Los Alamos National Laboratory

Review of the GMD Benchmark Event in TPL-007-1

September 2015

Figure 2. PDF for independent peak geo-electric field magnitude observations for a subset of the IMAGE magnetometer stations. The solid lines are the extrapolations using power law fits to the extreme events.

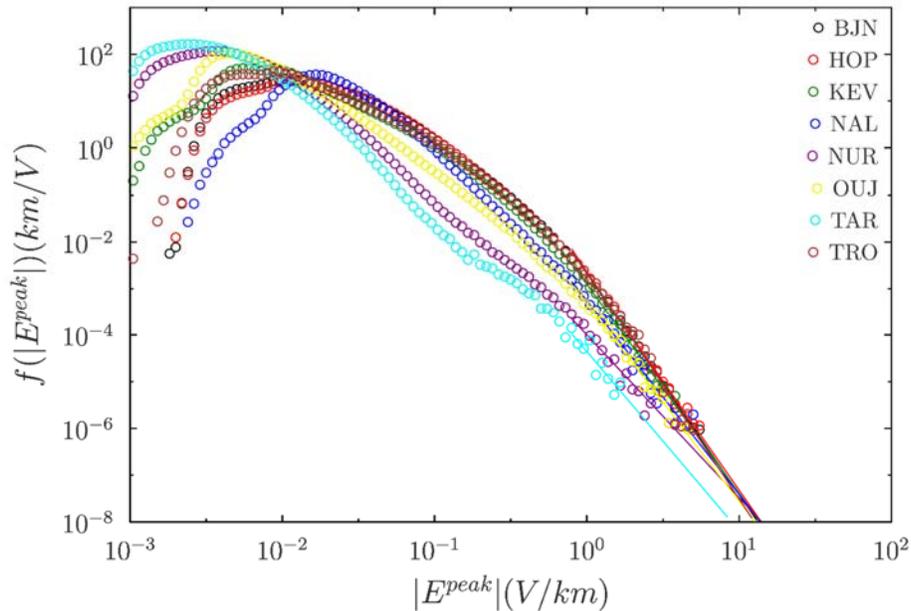
4. Did you consider parametric forms for the distributions in Figure 2? If something fit well, you wouldn't need to extrapolate and the integral would be easier.

9. Page 5: What power laws did you use? Not sure how they show a long tail but I may be misunderstanding Figure 2. It would be good to give a bit more detail here on how you do this.

we believe the power-law extrapolation over less than one order of magnitude is an appropriate approach.

Backhaus/Rivera: We did not try a discrete set of power laws. The power law was a best fit power law decay to the tail of the distribution function. We did not consider other canonical forms.

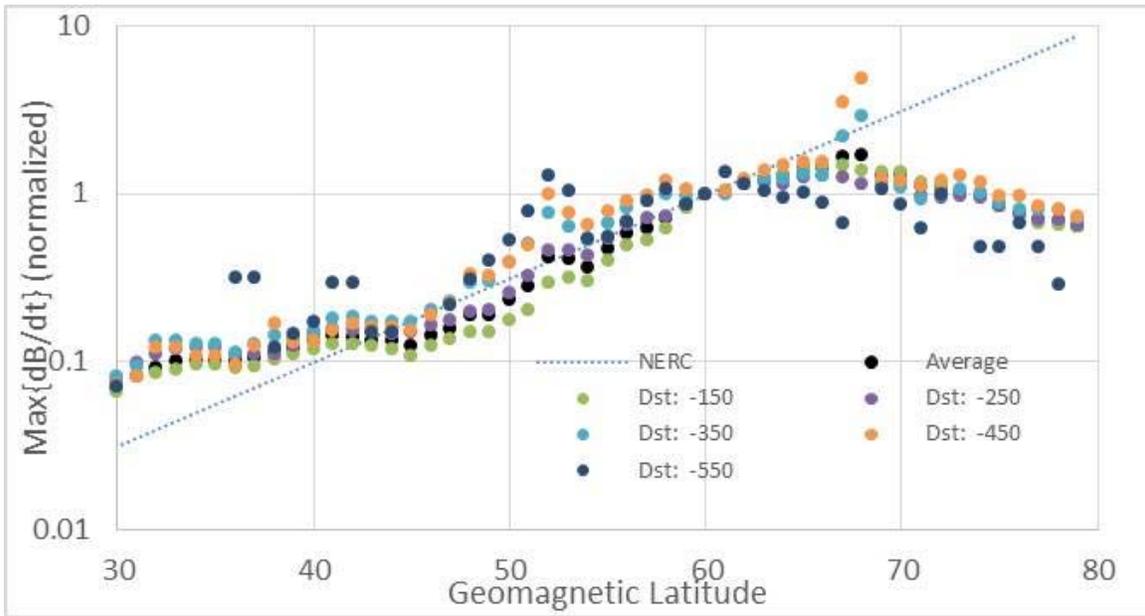
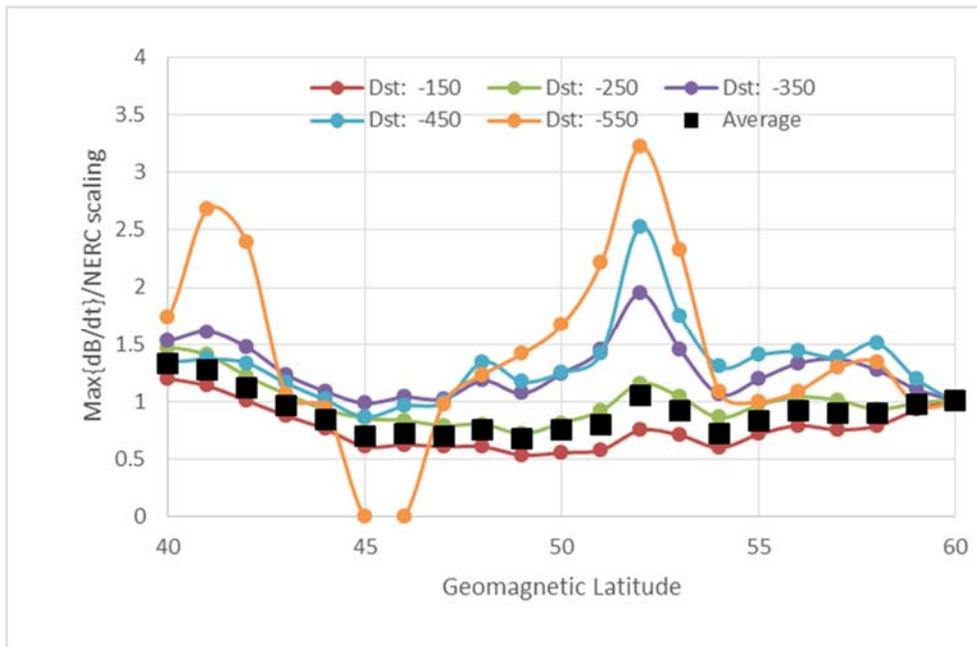
2. Regarding the latitude scaling and use of Dst: For the latitudes you consider, Dst may not be the best index. It represents the ring current, while the magnetic disturbances at high latitudes are due to the electrojets, which are more related to the Auroral Electrojet (AE) index. While Dst and AE are also correlated to some degree, using AE may give you a cleaner signature in Figs 4 and 5.

Backhaus/Rivera: We agree. We have done a preliminary analysis using AE index, as well as the Kyoto Sym-H index, however, we have not yet completed this work. Once complete, we will include it in subsequent journal papers. However, our preliminary analysis shows that no change is expected in the analysis results presented in the report. For the large events that contribute to the Dst<-400 plot in Figure 5, AE and Dst are sufficiently correlated that AE selects the same subset of events as Dst. The plot in Figure 5 will remain the same.

Backhaus/Rivera: We agree that the latitude scaling of the geo-electric field needs to be a function of the magnitude of the event. Our analysis in Figure 5 already shows this effect. We would very much like to perform this analysis to extract a magnitude-dependent latitude scaling function that better represents the spatial distribution of the GMD hazard. Our approach would be very similar to the one you describe above; however, limitations of time and funding keep us from pursuing this path. Until we are able to complete this work, we believe our recommendation (see page 11 of the report) of an additional factor of two safety in the geomagnetic mid-latitudes (50–55 degrees) is a prudent, but not overly alarmist.

Figure 4. USGS earth layer resistivity data for the Cascade Sierra region

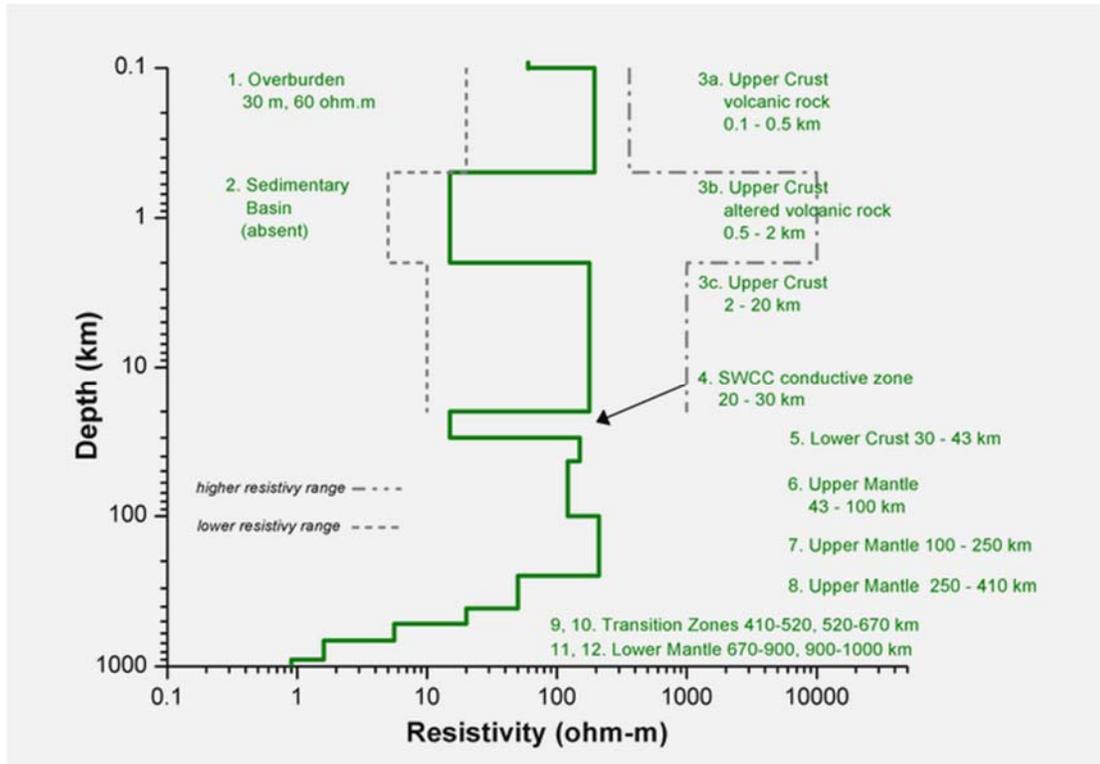
8. *In considering the uncertainty in earth conductivity data, Figure 6 is for the Cascade Sierra region but the subsequent analysis is for a Florida region. Is it even important to mention that initial investigations used the Florida region*

Backhaus/Rivera: No, it is not. We did the same analysis for all the regions. The text is a holdover from a previous draft when a second figure showing the analysis for Florida was inserted. That figure was removed, but the text inexplicably remained. The text has been removed.

Figure 5. Worst case (blue bars) and best case (grey bars) peak geo-electric field values for a subset of USGS regions that report uncertainty ranges in conductivity values. The orange bars are the values obtained using the USGS recommended value.

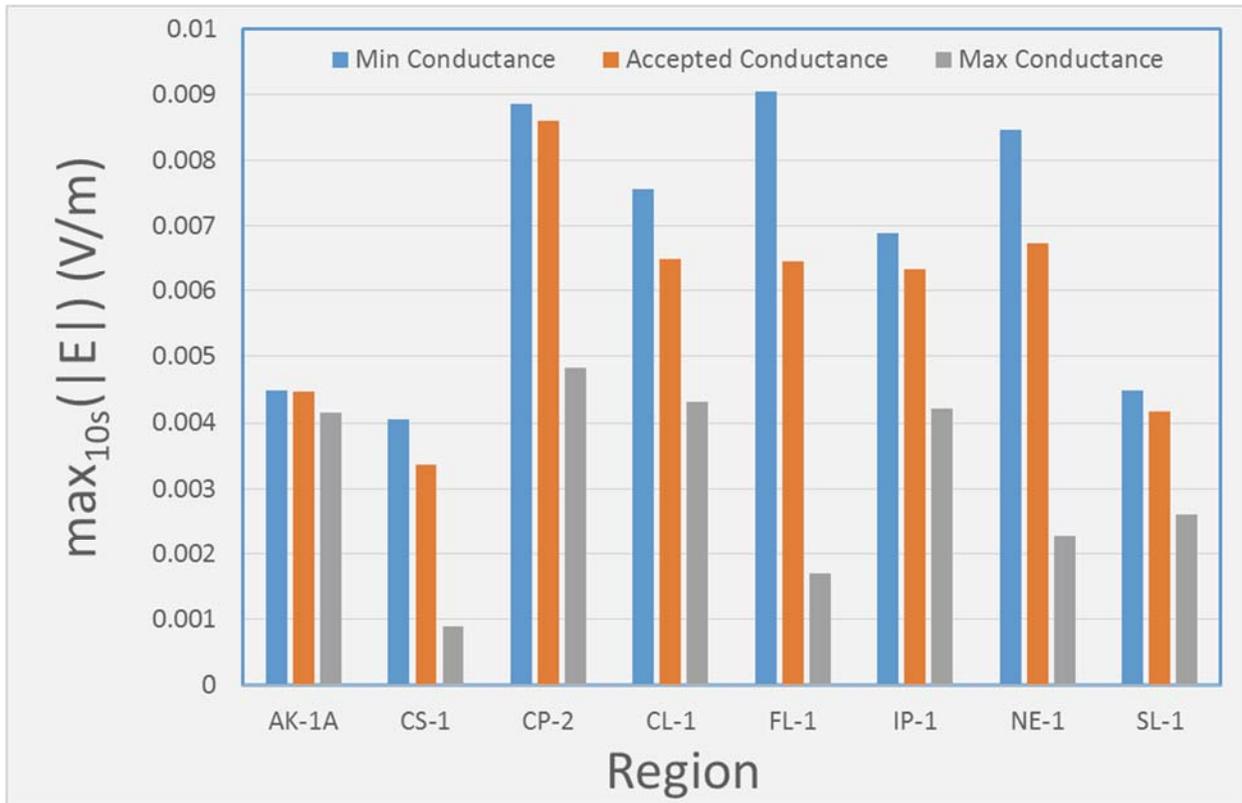
3. On the Sensitivity study on earth conductance - your approach is to vary the top 4 layers of the USGS model. It is the only bit I actually disagree with. For the frequency of fluctuations we’re dealing with, the work of Anti Pulkkinen showed that the layers that have the biggest effects are not near the top but rather exist in the 10-100km range of depth - so for your sensitivity study you should vary those layer’s resistivity range. This is kind of hinted at by your result - where up to three orders of magnitude resistivity variation in say the second layer results in only factors of 2-4 and often less variation in the induced field. That rather speaks to the induced electric field strength being rather insensitive to the variations of resistivity in the top layers. I suggest that this part of the work needs to be redone.

Backhaus/Rivera: We agree that the computed geo-electric field is more sensitive to uncertainty in the lower layers. However, the USGS data available to us report resistivity ranges only for the upper layers and not for the lower layers. The intent of this report is to discover and advise on the unresolved uncertainties within the TPL-007-1 screening process. If these uncertainties are overestimated without justification, the end result may be over-application of very expensive GMD mitigation measures on a nationwide basis. Therefore, we have chosen our current approach to avoid alarmism by only considering layers in the geological model where USGS provides ranges, even though those ranges are ill defined, with descriptive phrases like “possibly representative.”

Our conclusion is that more work needs to be done to generate better-defined Earth layer conductivity data sources for use in TPL-007-1. To address your concerns, we have added a

discussion of this matter indicating that the reported ranges in Figure 7 likely underestimate the true range when uncertainty in the resistivity of the lower layers is included.
